PURGE VALVE OPERABILITY REPORT

SNUPPS PROJECT

DECEMBER 1983

This report has been prepared to allow the NRC to close out the confirmatory items (Number 28, TMI Action Plan II.E.4.2) for Callaway and Wolf Creek.

CONTAINMENT PRESSURE TRANSIENT WITH
PURGE VALVE CLOSURE TIMES

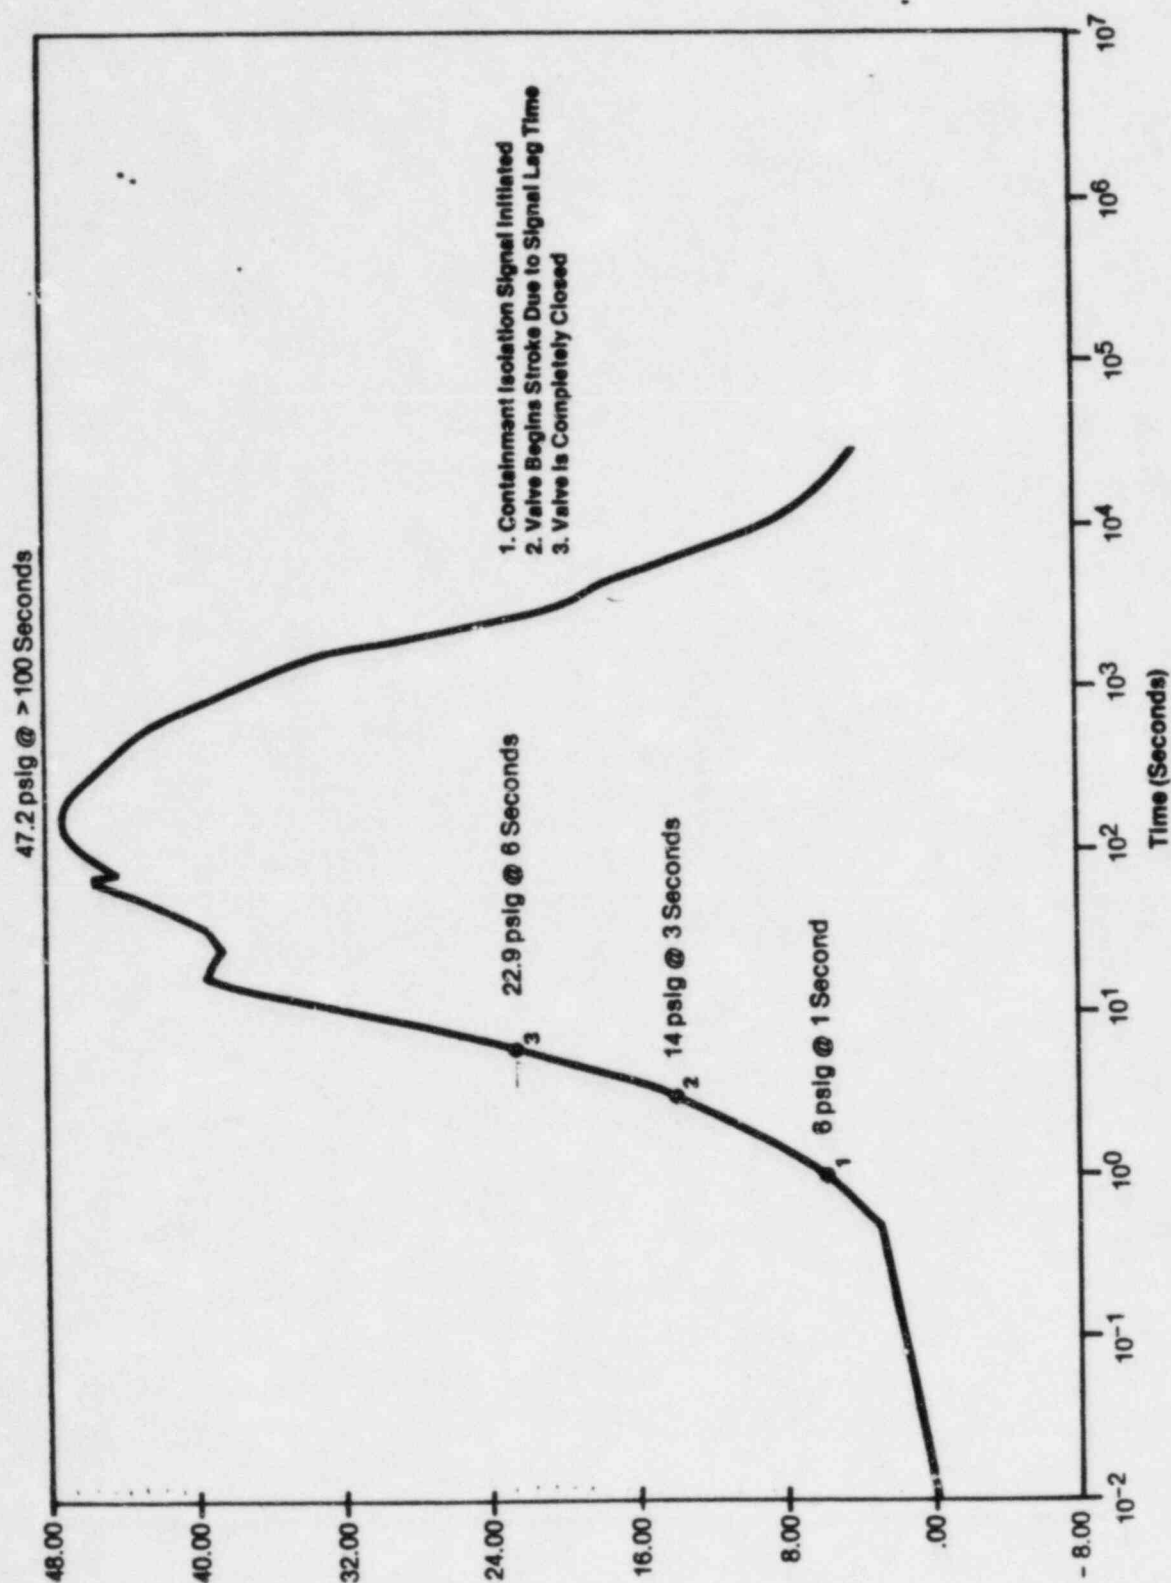
1. The ΔP across the valve is in part predicated on the containment pressure and gas density conditions. What were the containment conditions used to determine the ΔP 's across the valve at the incremental angle positions during the closure cycle?

The LOCA containment conditions utilized in predicting the ΔP across the valves were extracted from the containment pressure-temperature analysis for the large LOCA which results in the peak contained pressure. The pressure response is shown in Figure 1, which also indicates the times that the valve receives a signal to close and the time that the valve is fully closed. When the valve is fully closed the containment pressure is 22.9 psig. As shown in Figure 1, the containment pressure rises from approximately 14 psig to 22.9 psig during the closure stroke; however, the pressure drop at incremental valve positions was calculated at the maximum pressure (22.9 psig: valve closed). This was done for conservatism.

As noted in the response to Item 1 and as shown in Figure 1, the containment pressure during the closure cycle was assumed to be 22.9 psig, which corresponds to the time at which the valve is fully closed ($T = 6$ seconds). The lag time between the receipt of the signal to close at 3 seconds and the initiation of valve motion has been taken into account. Tests have ensured that closure is accomplished within the required 3 seconds from receipt of the closure signal.

LOCATION OF VALVES IN CONTAINMENT PURGE SYSTEM
(Supply Line)

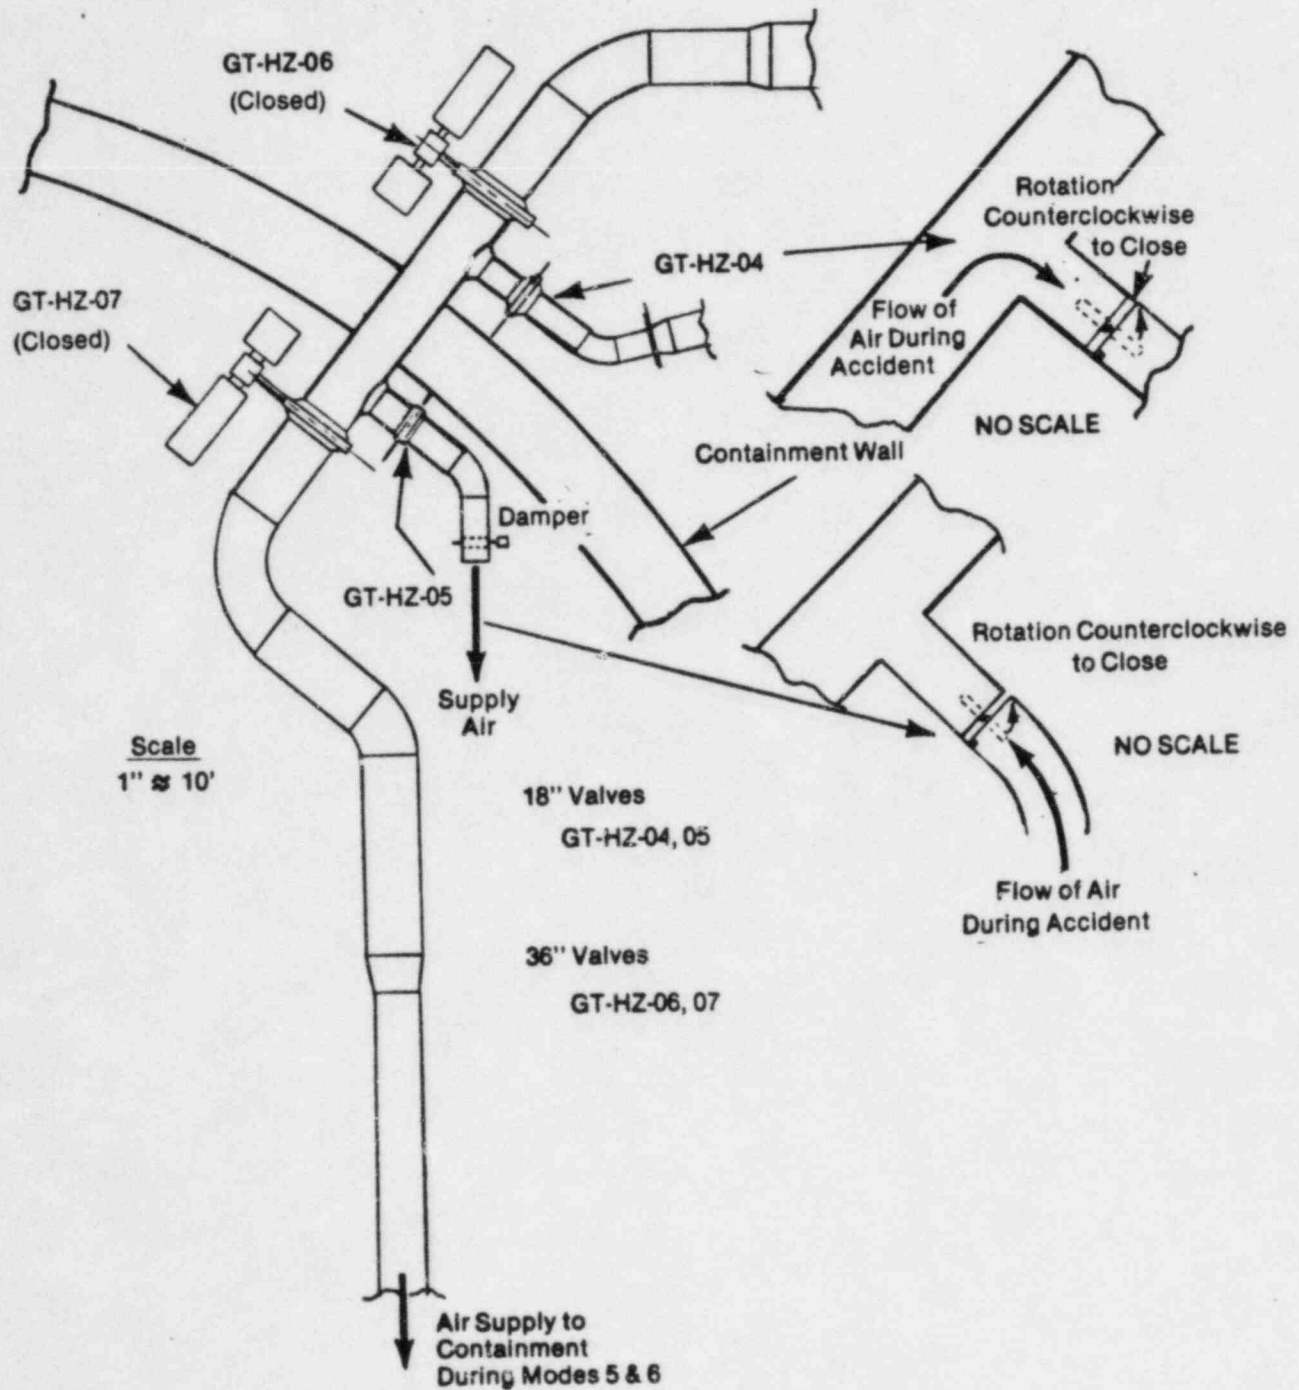
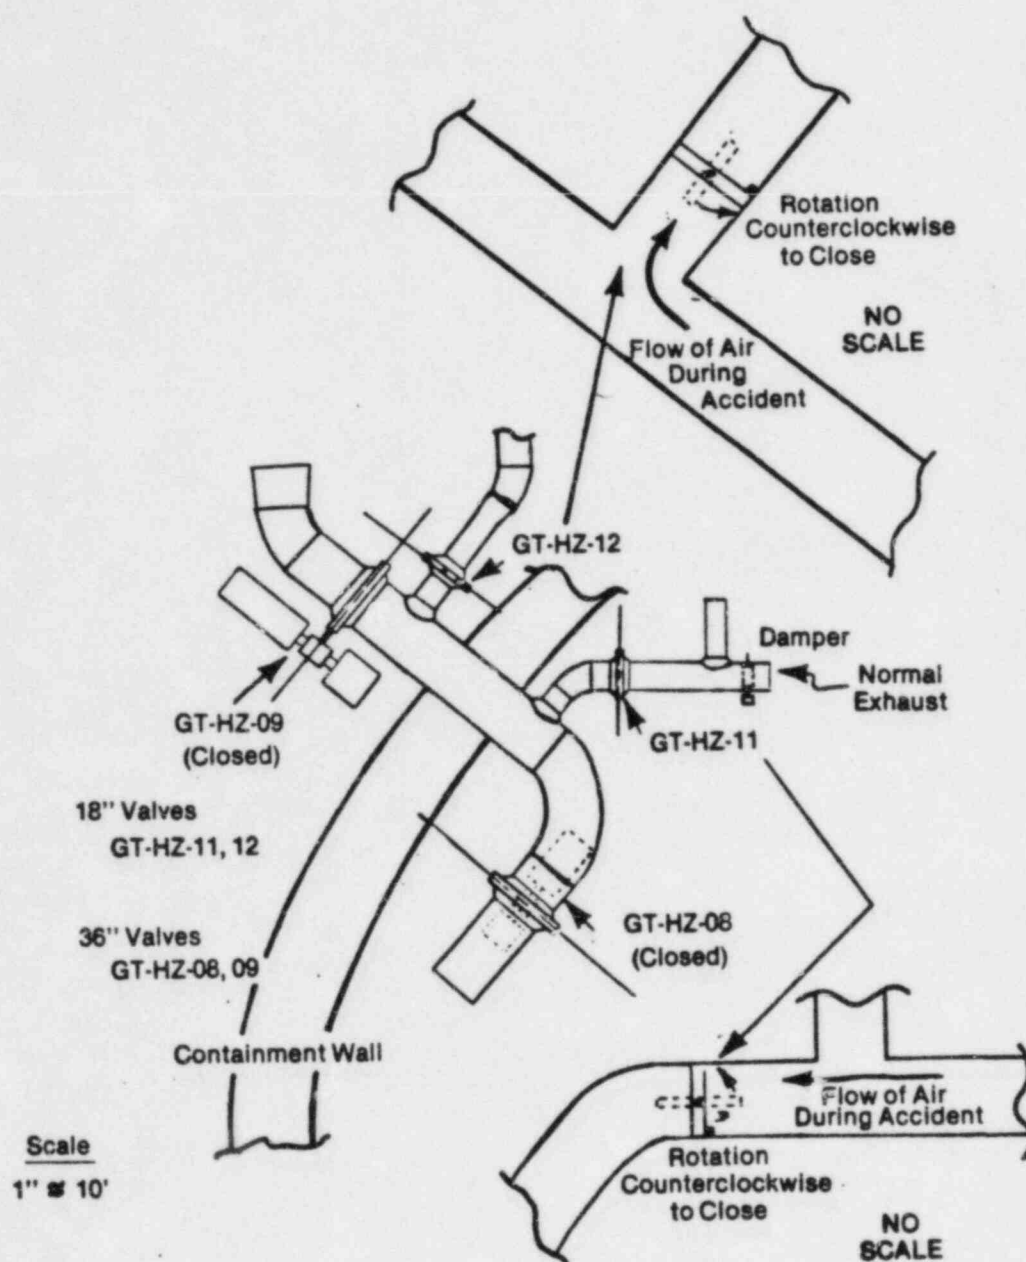
3. Were installation effects accounted for in the determination of dynamic torques developed? Dynamic torques are known to be affected for example, by flow direction through valves with off-set discs, by downstream piping backpressure, by shaft orientation relative to elbows, etc. What was the basis (test data or other) used to predict dynamic torques for the particular valve installation?

The installation of the containment purge valves is shown in Figure 2. The 36-inch large volume, shutdown purge valves are closed during modes 1, 2, 3, and 4, as required by the plant technical specifications. The 18-inch mini-purge valves on the supply (GT-HZ-04 and GT-HZ-05) and the exhaust (GT-HZ-11 and GT-HZ-12) are designed, tested, and qualified in order to allow them to be open at any time during the plant life.

The mini-purge valves and piping are connected to and are part of the containment penetration for the 36-inch shutdown purge system. Plant arrangements and available space have dictated the arrangements shown in Figure 2. It was not possible at the time of the initial routing to provide separate penetrations or straight piping on either side of the mini-purge valves or between them.

As shown in Figure 2, the valves inside the containment have elbows either upstream or downstream of the valves. Valve GT-HZ-05 has a 45-degree elbow upstream and valve GT-HZ-11 has a 90-degree elbow downstream. Any asymmetric flow conditions developed due to these elbows will tend to assist valve closure. Refer to Figure 2 for the direction of flow and valve closure. The installation of all mini-purge valves is similar in that the valve shafts are vertical and the Bettis actuators are installed below the piping with the common actuator shaft (connecting the air side and spring side actuators) parallel to the piping. The actuator shaft drives a scotch yoke which is attached to the valve shaft. The valve shaft (2-inch diameter) penetrates the center of the valve disc (~4-1/2 inches thick) and is completely enclosed by the valve disc. The shaft/disc arrangement is symmetrical.

The valves located outside of the containment (GT-HZ-4 and GT-HZ-12) are located at the end of 36-inch x 18-inch tees. The flow into the valve will be highly turbulent and well mixed; however, if the flow is postulated to flow predominantly to the outside of the piping, the asymmetric flow would tend to resist valve closure. The asymmetric flow is not expected to be as significant for flow exiting the 36-inch x 18-inch tee as it would be for an 18-inch 90-degree elbow.

ACTUATOR DATA — SCOTCH YOKE

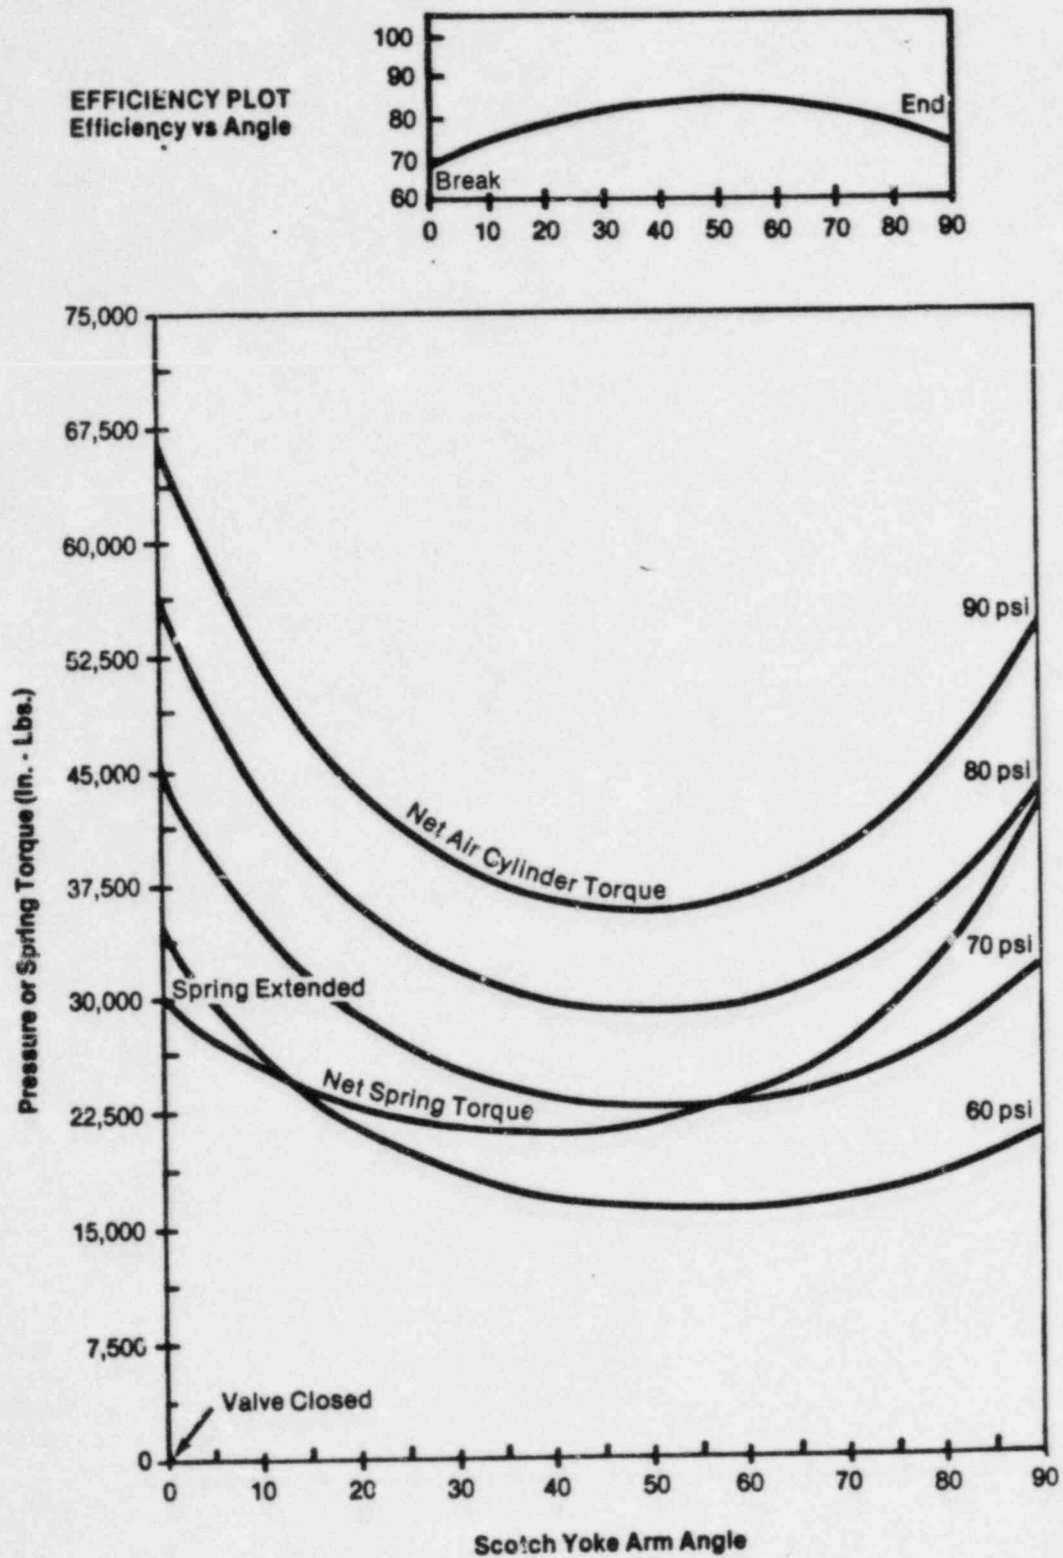
4. When comparing the containment pressure response profile against the valve position at a given instant of time, was the valve closure rate vs. time (i.e. constant or other) taken into account? For air operated valves equipped with spring return operators, has the lag time from the time the valve receives a signal to the time the valve starts to stroke been accounted for?

Since the air cylinder is vented through the large Versa valve opening (3/4-inch diameter), the air cylinder will depressurize rapidly. As shown in Figure 3, approximately 80 psig in the air cylinder is required to balance the spring force and maintain the actuator/valve in the open position without flow. A pressure regulator is provided on the valve to allow a reduced pressure in the air cylinder. This regulator will be set to ensure that the valve remains fully opened. Depressurization of the air cylinder with respect to time is shown in Figure 4. The times required to vent the cylinder from any initial pressure less than 100 psig can be taken from Figure 4. For example, depressurization from 100 to 80 psig is accomplished in approximately 0.1 second when venting to atmospheric pressure. As noted in the response to Item 9, venting of the accumulators to a positive containment pressure will not affect the closure time.

ACTUATOR DEPRESSURIZATION TRANSIENT

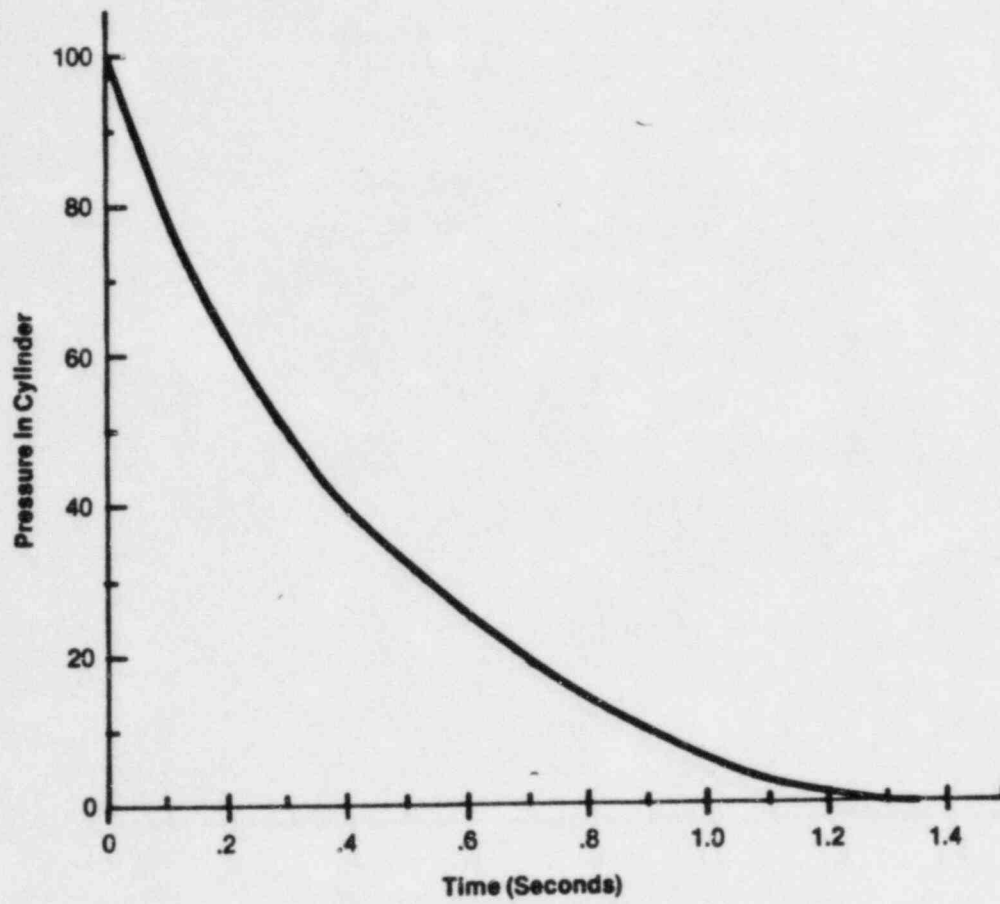
9. For those valve assemblies (with air operators) inside containment, has the containment pressure rise (backpressure) been considered as to its effect on torque margins available (to close and seat the valve) from the actuator? During the closure period, air must be vented from the actuators opening side through the solenoid valve into this backpressure. Discuss the installed actuator bleed configuration and provide basis for not considering this backpressure effect a problem on torque margin. Valve assembly using 4 way solenoid valve should especially be reviewed.

Figure 4 shows the depressurization transient for the actuator. As shown therein, the actuator depressurizes very rapidly. Since the unpressurized side is continuously vented to the containment, it will be pressurized along with the containment. There will be no adverse effect on the valve closure rate. In fact, the closure rate may increase due to prepressurization of the vented side.
